JUNIPER 9-322
ENERGY STAR

PROJECT NAME
LECCO RIDGE

SHEET TITLE AREA CHARTS	
SCALE 3/16"=1'-0"	BY ZMP
DATE APR 2017	TYPE

TOWN OF MILTON
PLANNING AND DEVELOPMENT
BUILDING PERMIT: 17-7104
BUILDING: REVIEWED
SCOTT SHERRIFFS JUN 13, 2017
PLANS EXAMINER DATE
Neither the issuance of a permit nor carrying out of inspections by the Town of Milton relieves the owner from full responsibility for compliance with the provisions of the Ontario Building Code Act and the Ontario Building Code, both as amended, as well as other applicable statutes and regulations of the Province of Ontario, By-laws of the Region of Halton and Town of Milton

BASEMENT FLOOR PLAN '3'

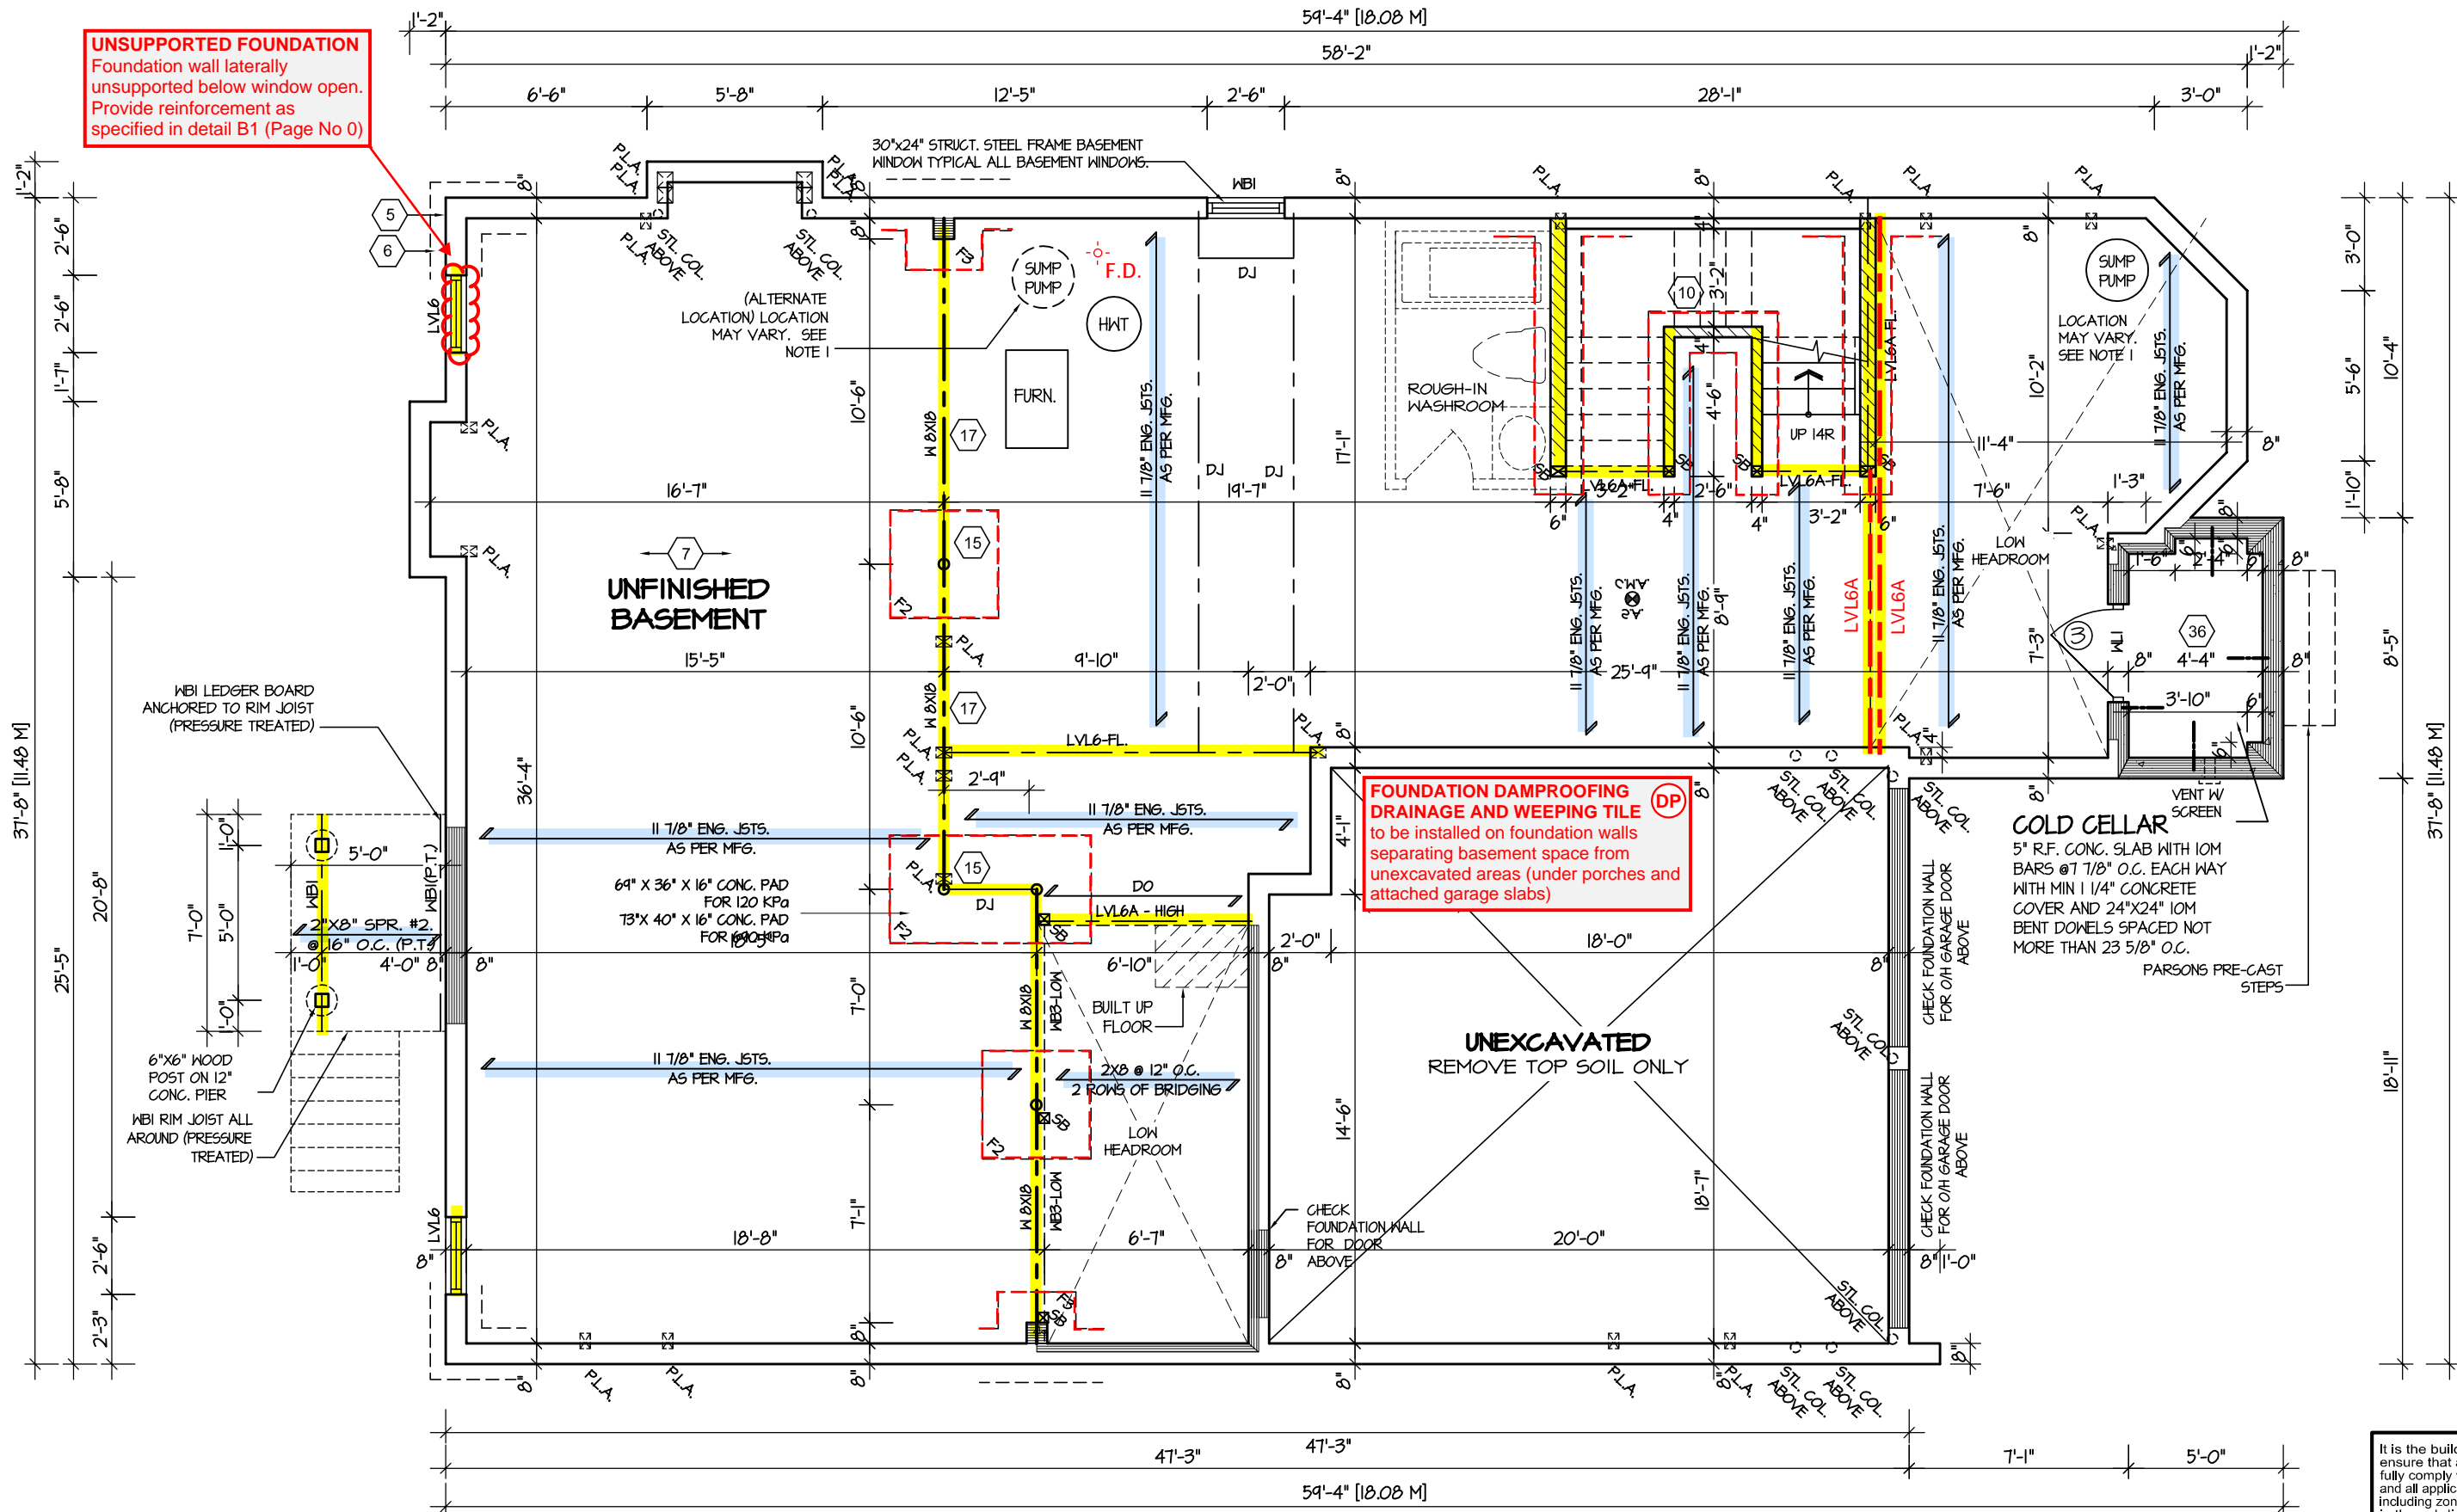
UNSUPPORTED FOUNDATION
Foundation wall laterally unsupported below window open. Provide reinforcement as specified in detail B1 (Page No 0)

FIRST FLOOR PLAN 3'

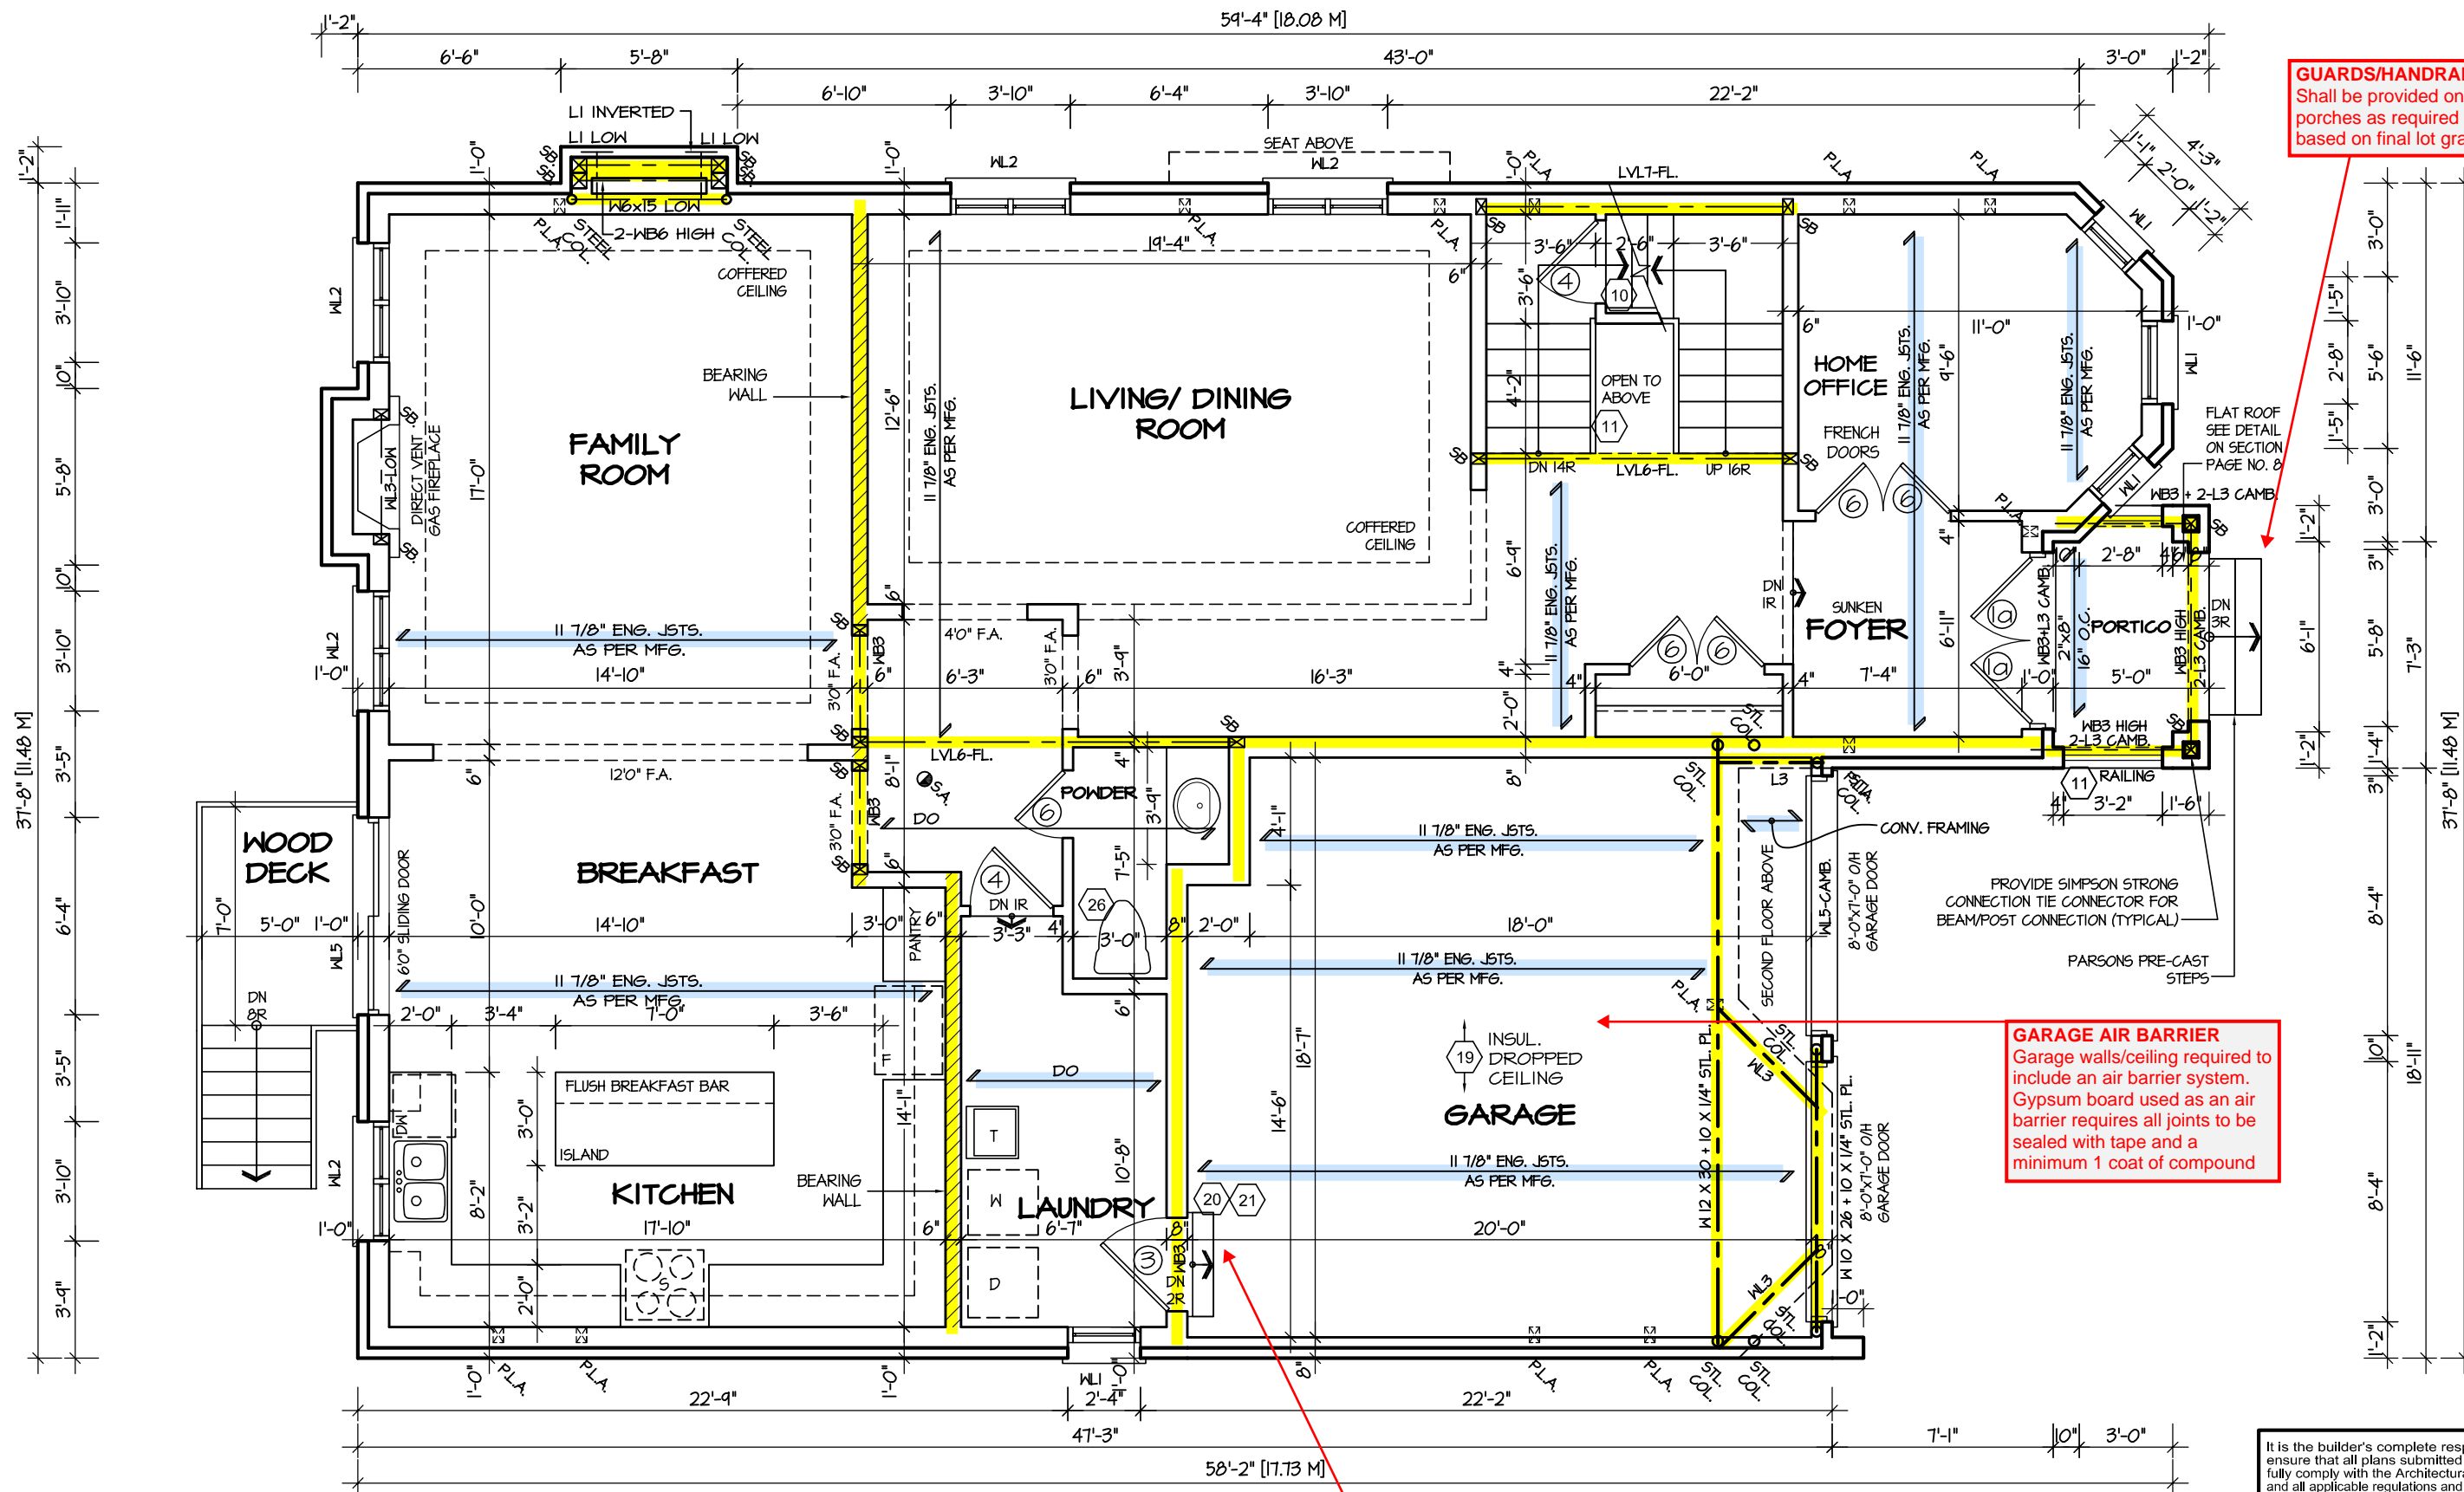
ENGINEERED FLOOR SYSTEM
Drawings to be read in conjunction with reviewed engineered floor system layout

SECOND FLOOR PLAN '3'

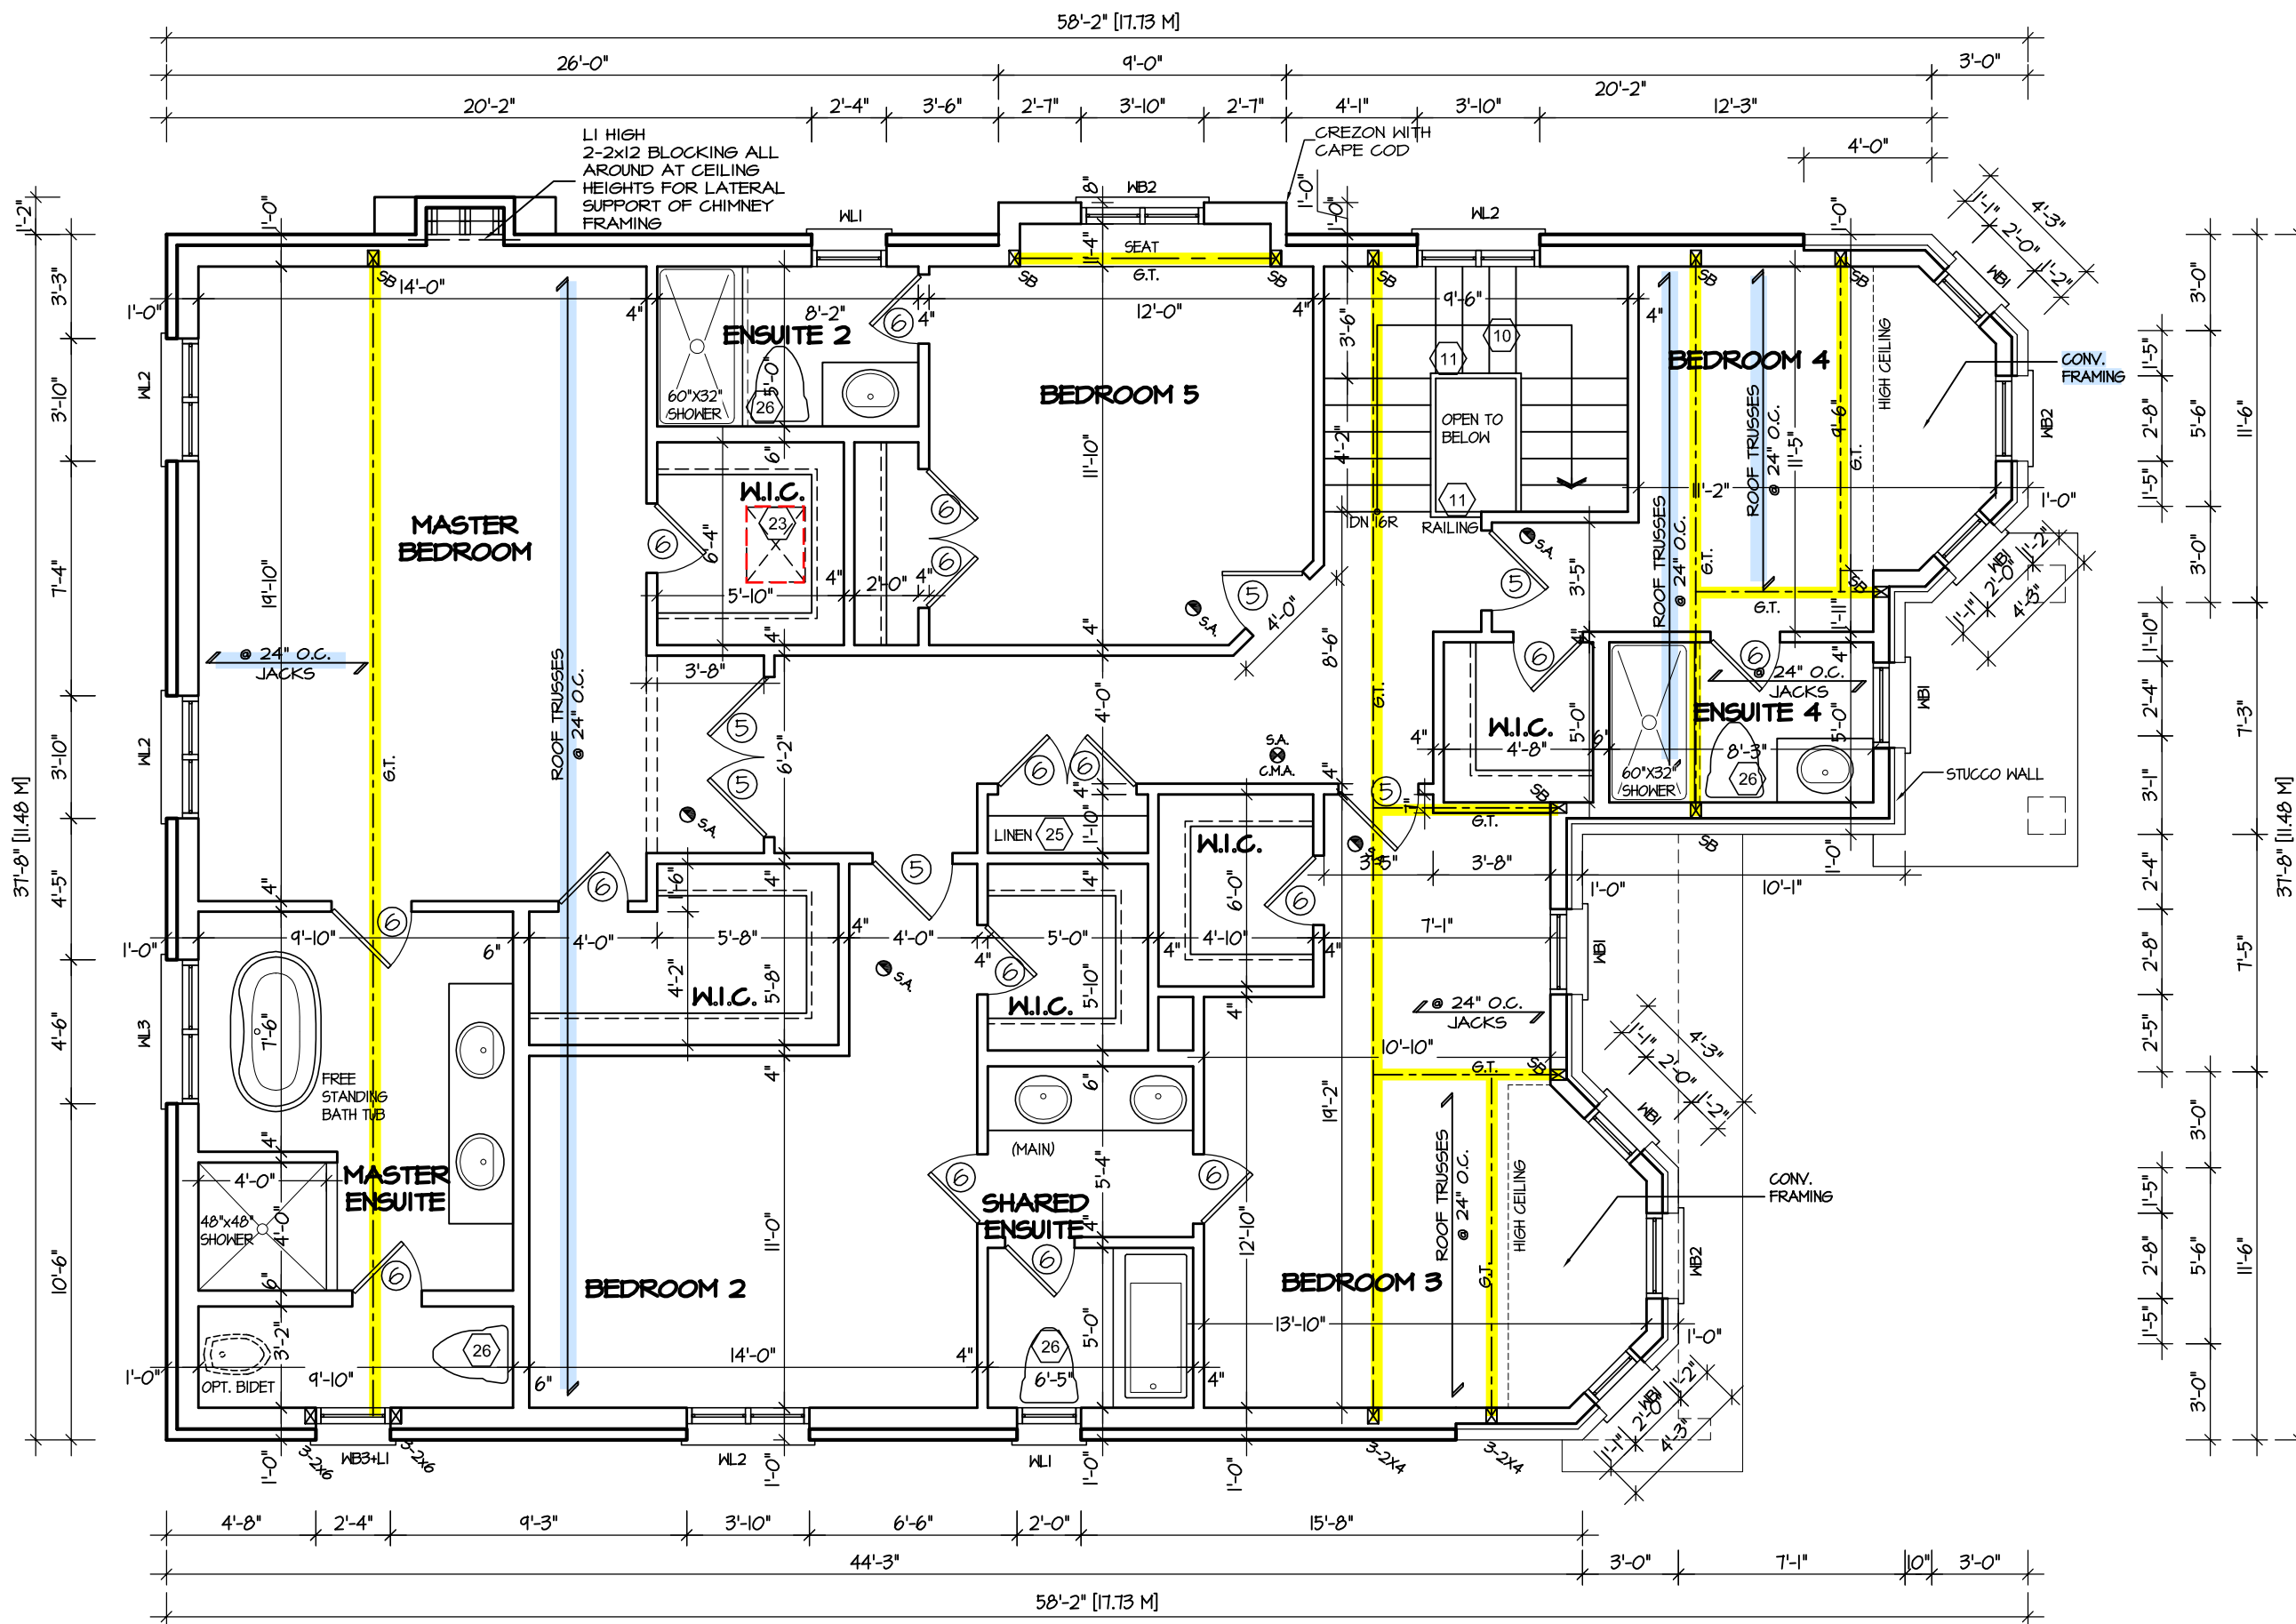
GUARDS/HANDRAILS
Shall be provided on porches as required based on final lot grading

GARAGE AIR BARRIER
Garage walls/ceiling required to include an air barrier system. Gypsum board used as an air barrier requires all joints to be sealed with tape and a minimum 1 coat of compound

GARAGE DOOR
Requires weatherstripping and a self closing device
